## Photomontages that Appear to be Grossly Misleading

## Anatomy of a Biala photomontage.

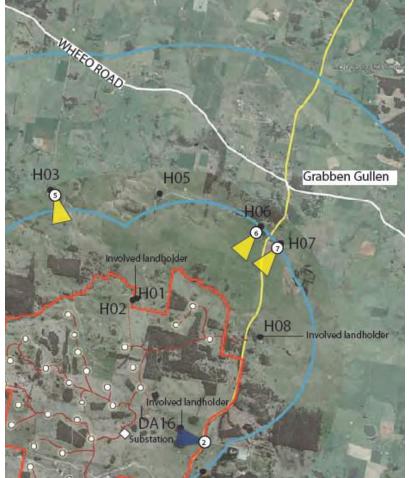
Firstly, there are no references to or guidelines for photomontages in the Clean Energy Council Best Practice Guidelines (2013)

Whilst GPS coordinates were recorded (as above), they were not published in the LVIA (SNH requirement) No doubt Time of Day was recorded for each photograph but not published (SNH requirement)

- that Newtricity provide GPS coordinates for each photomontage location.

- that Newtricity advise the dates and times on which all photomontage base photographs were taken.
